# Access Compliance Report

## Public Rights-of-Way

Intersection ID: 7606	Main Street: STARITA_RD	Cross Street: WOODPARK_BV	Location: SW
ADA ID: DAFFFA8D3650	Ramp Type: Perp	Initial Pass/Fail: Fail	Overall Compliance: No
			Severity Score: 50

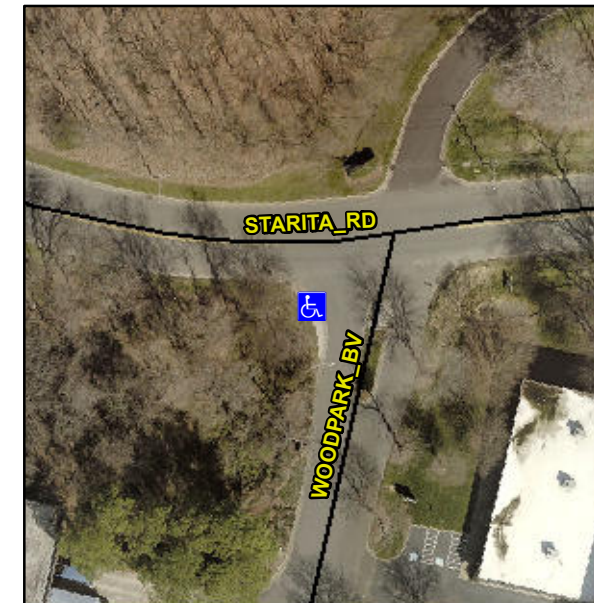
**Not Found, R304.2.2, R304.5.3**

Compliance	Description	Data	Compliance	Description	Data
N/A	Ramp Length (in)	38.0	No	Ramp Slope (%)	16.7
Yes	Ramp Width (in)	68.0	No	Ramp XSlope (%)	11.7
N/A	Flare Type LT	N/A	N/A	Flare Type RT	N/A
N/A	Flare Slope LT (%)	N/A	N/A	Flare Slope RT (%)	N/A
N/A	Flare Traversable LT?	N/A	N/A	Flare Traversable RT?	N/A
N/A	Landing Length (in)	N/A	N/A	DWS Provided?	N/A
N/A	Landing Width (in)	N/A	N/A	DWS Contrast?	N/A
N/A	Landing Slope (%)	N/A	N/A	DWS Length (in)	N/A
N/A	Landing X Slope (%)	N/A	N/A	DWS Full Width?	N/A
N/A	Landing Curb? (Y/N)	N/A	N/A	DWS Offset (in)	N/A
N/A	Shared Landing?	N/A			
N/A	Gutter Ponding?	N/A	N/A	Gutter Slope (%)	N/A
N/A	Gutter Lip Ht (in)	N/A	N/A	Gutter X Slope (%)	N/A
N/A	Painted X Walk1?	No	N/A	Painted X Walk2?	N/A
	X Walk 1 Direction	To NE		X Walk 2 Direction	N/A
N/A	X Walk 1 Width (in)	N/A	N/A	X Walk 2 Width (in)	N/A
	X Walk 1 Slope (%)	6.7		X Walk 2 Slope (%)	N/A
	X Walk 1 X Slope (%)	13.5		X Walk 2 X Slope (%)	N/A

**Remove & Replace Entire Ramp.**
